**ADDENDUM NO. 1**

Date: May 28, 2021

Bid Name Loblolly Woods Park Boardwalk Reconstruction

Bid No.: WSPP-210047-DM

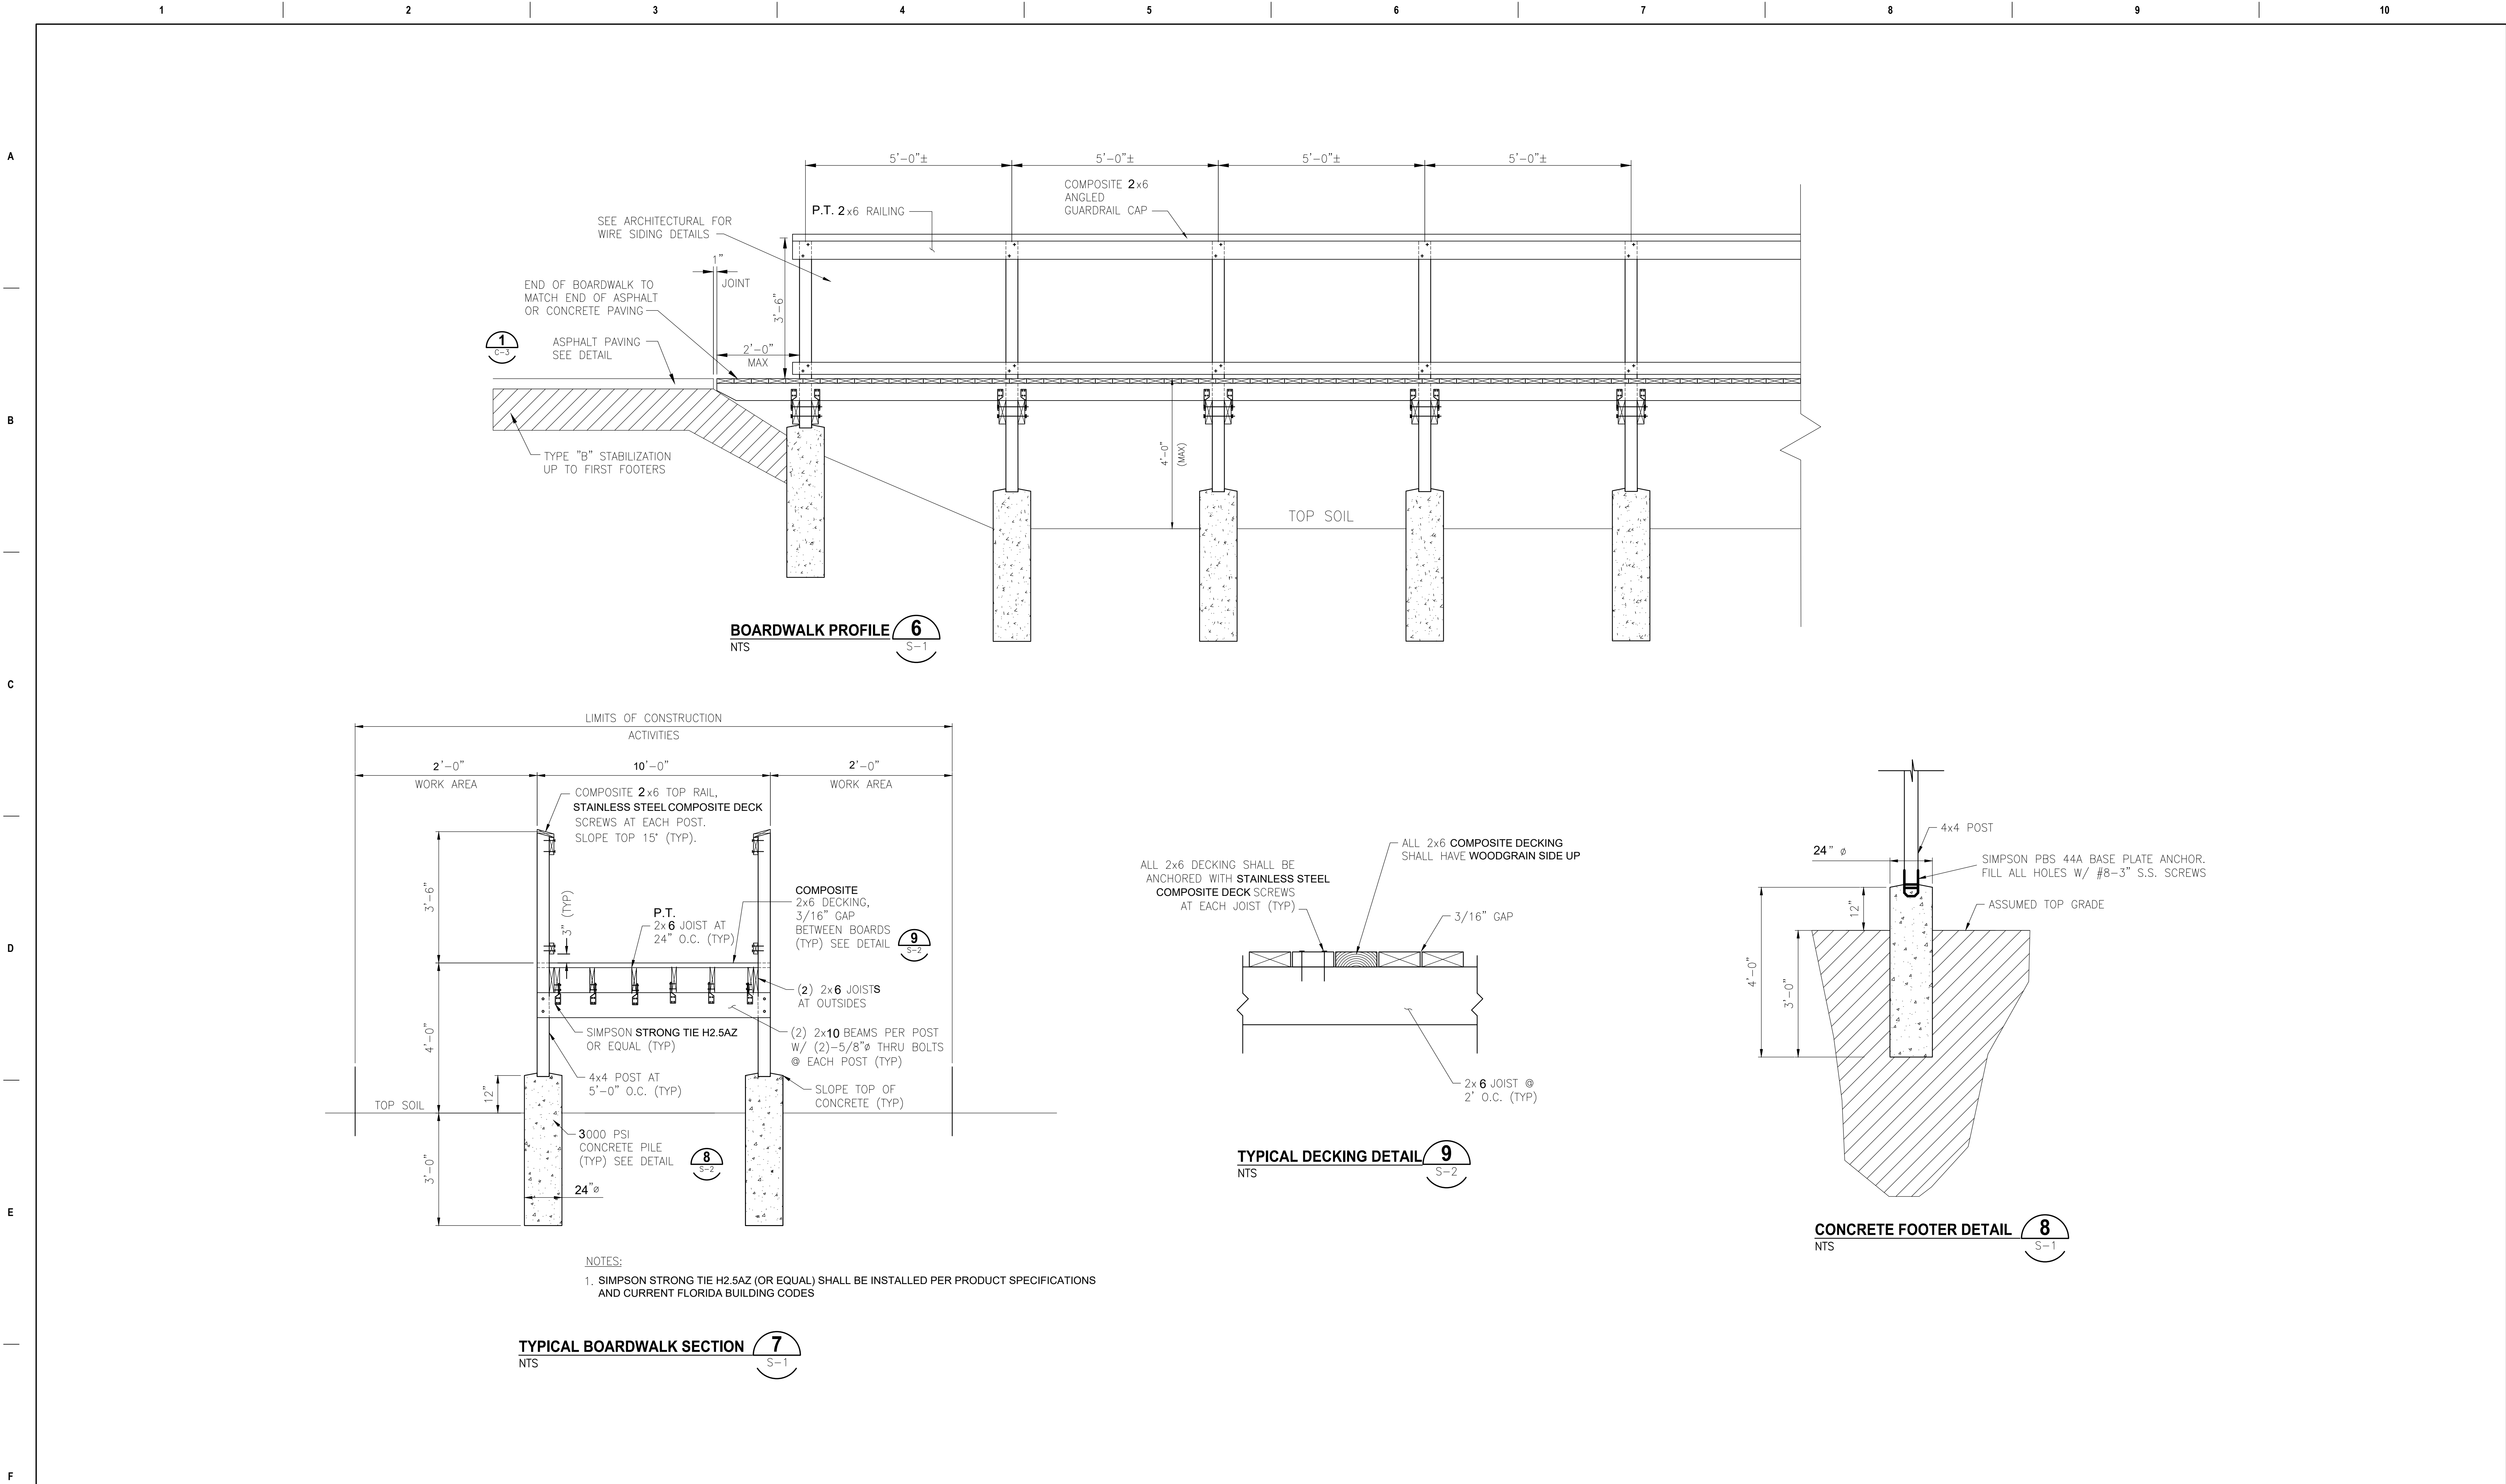
13. Question: The plans show a single joist, but the existing joist is double.  
Answer: Revisions have been made to Sheets S-2 and A101 – See attached.
